SERVICE LETTER

No. 705

Subject: Modification of Turbocharger Oil Tanks and Related Installation -- reference attached AiResearch Service Bulletins No. 14.1.10 and 14.1.11, both dated February 6, 1974.

MODIFICATION OF TURBOCHARGER OIL TANKS AND RELATED INSTALLATION

FIG. 1

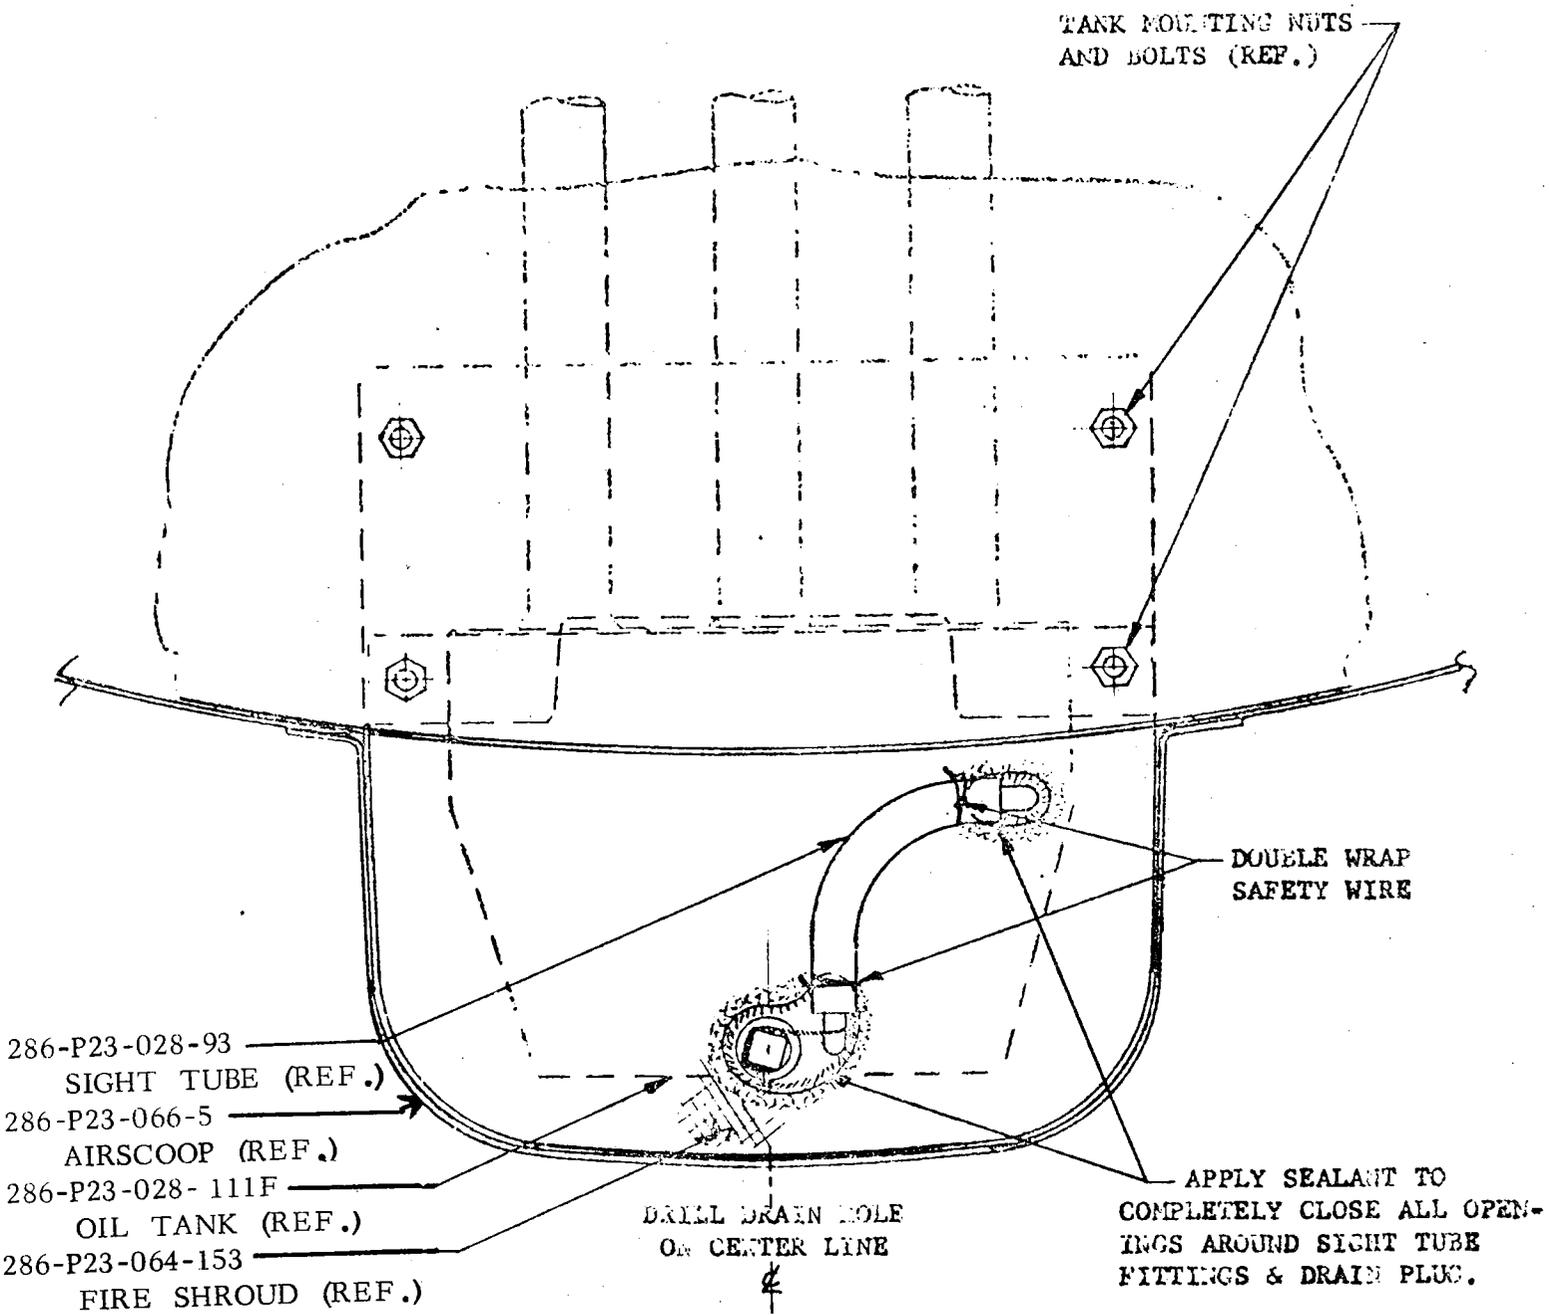
- F. Seal openings around sight tube fittings with supplied sealant as illustrated on Figure 1, L.H. R.H. Follow application directions on container. (Reference - Piper Service Bulletin No. 375 dated June 20, 1973.)

FIG. 2

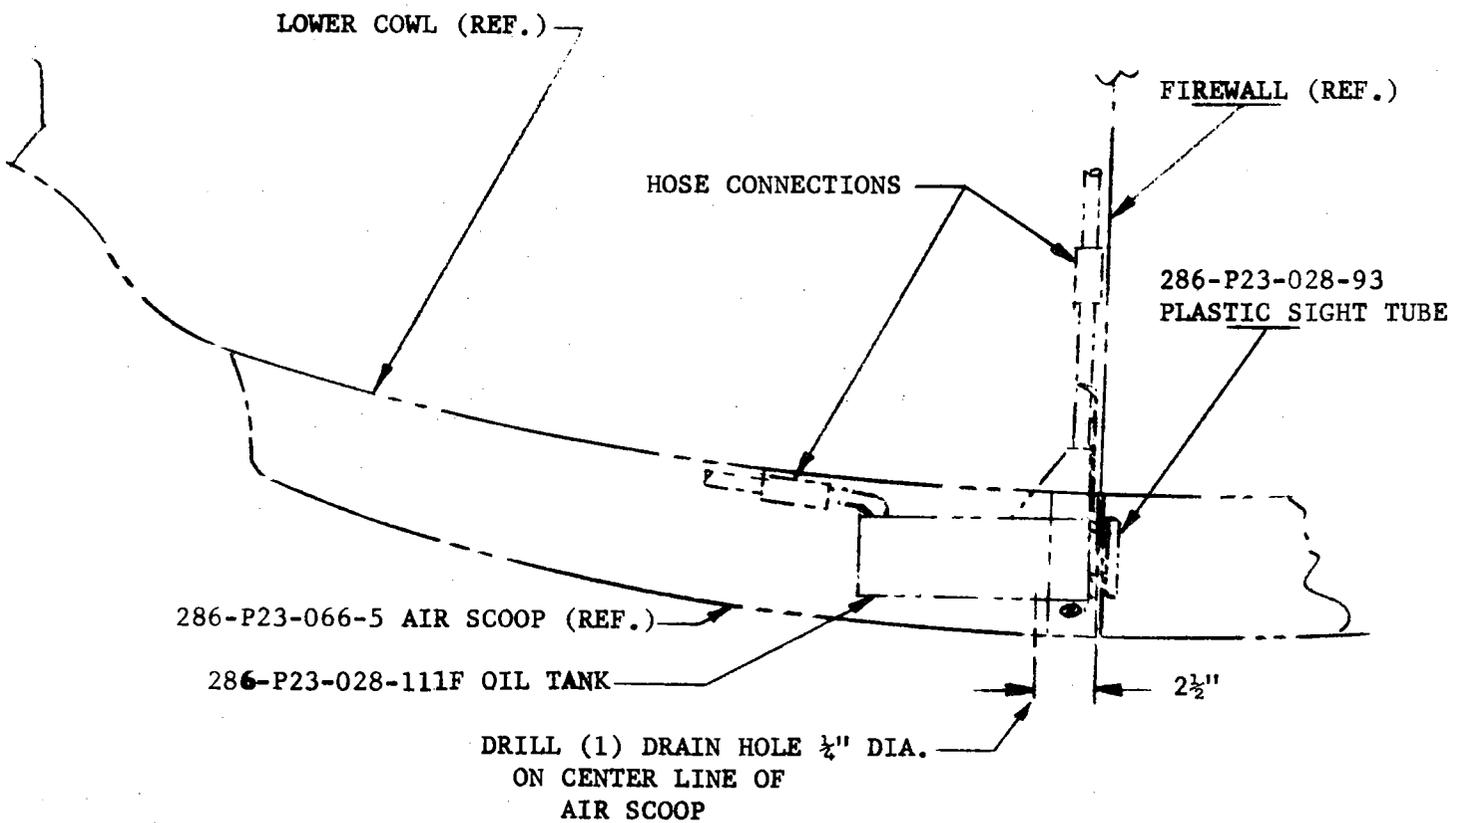
- G. Drill drain hole (1) on bottom air scoop (286-P23-066-5) as illustrated on Figure 2. L.H. R.H.

FIG. 1

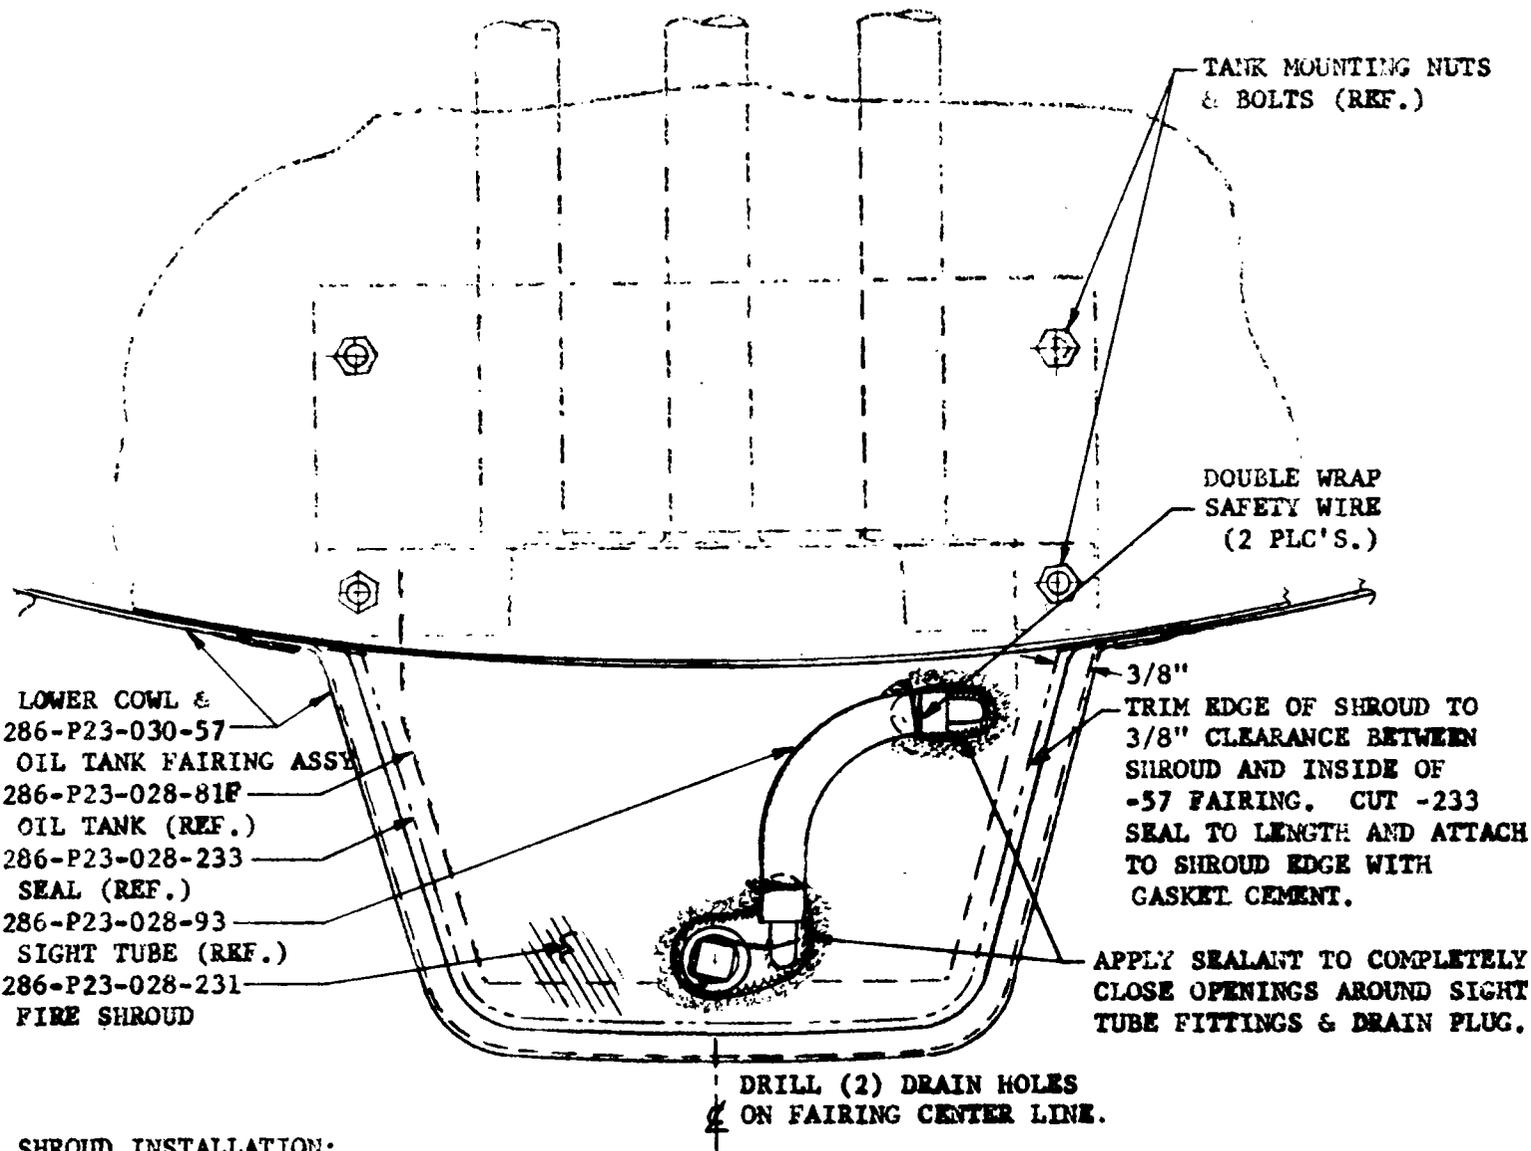
- D. Install lower fireshroud (286-P23-028-231) as illustrated on Figures 1 and 2.
- E. Install improved oil tank (286-P23-028-81F) in reversed order from Step C to A.

- F. Install plastic oil level sight tube (286-P23-028-93) as installed on old tank. R.H. L.H.
- G. Seal openings around sight tube fittings with supplied sealant as illustrated on Figure 1. L.H. R.H. Follow application directions on container.

- A. SHROUD TO BE SANDWICHED BETWEEN EXISTING ENGINE FIREWALL AND LOWER HALF OF OIL TANK MOUNTING PLATE.
- B. CHECK LOCATIONS OF (2) .09 PILOT HOLES IN SHROUD TO MATCH (2) LOWER BOLT HOLES IN OIL TANK PLATE. DRILL HOLES TO ACCEPT 3/16" BOLTS.
- C. LOCATE SHROUD AS IN (A), TRIM UPPER EDGE AS REQUIRED TO PERMIT ATTACHMENT TH (2) LOWER TANK BOLTS.

FIG. 2

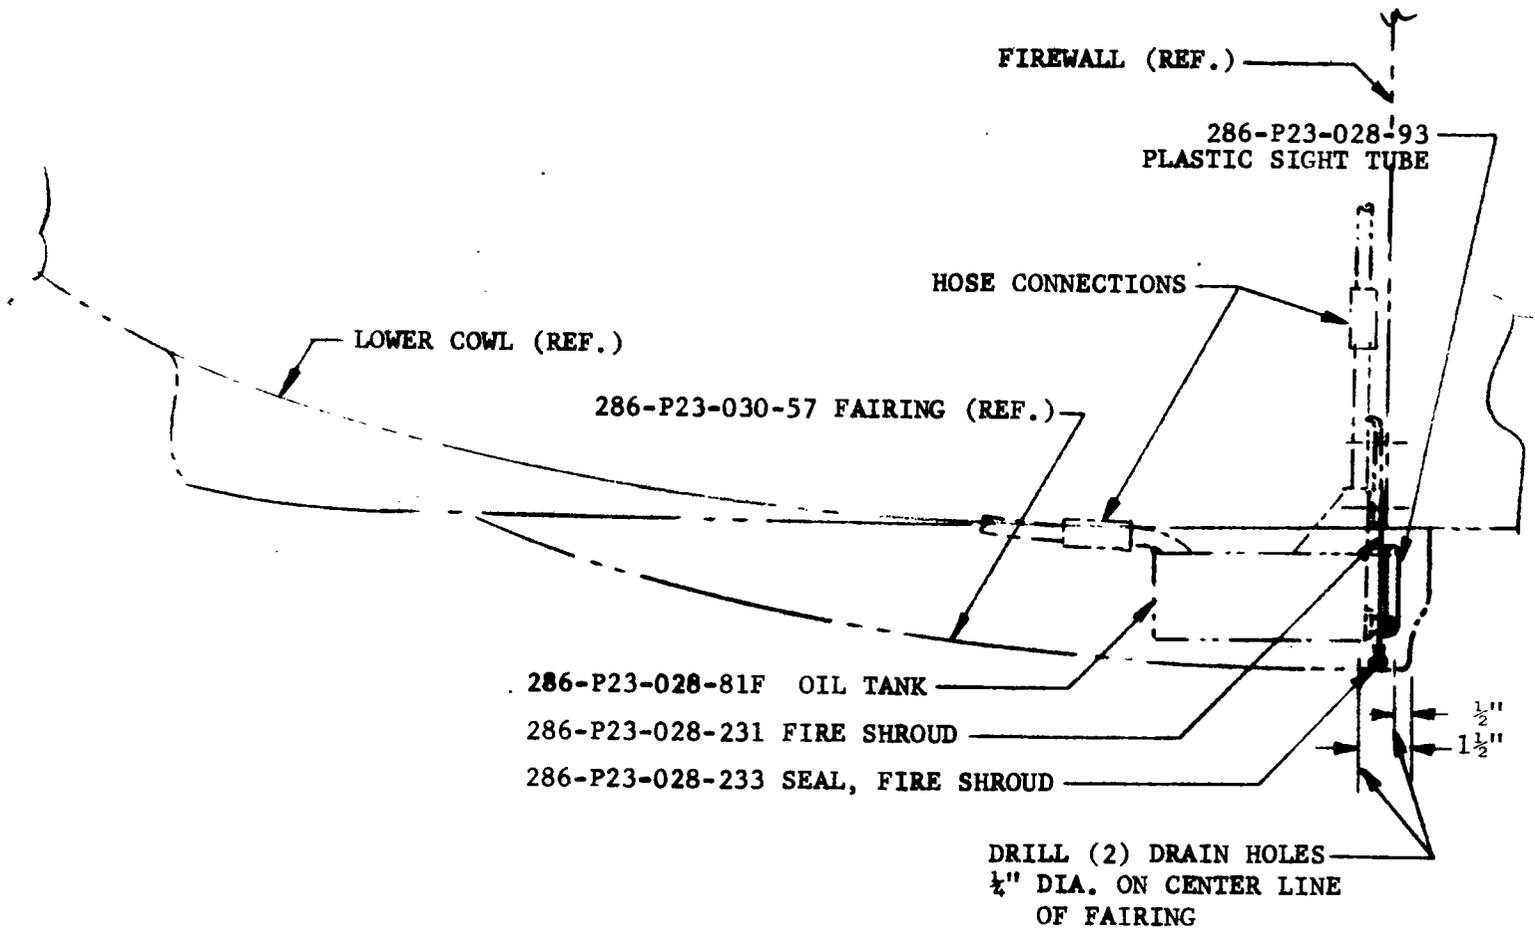
- H. Drill drain holes (2) on fairing, oil tank (286-P23-030-57) as illustrated on Figure 2. R.H. L.H.
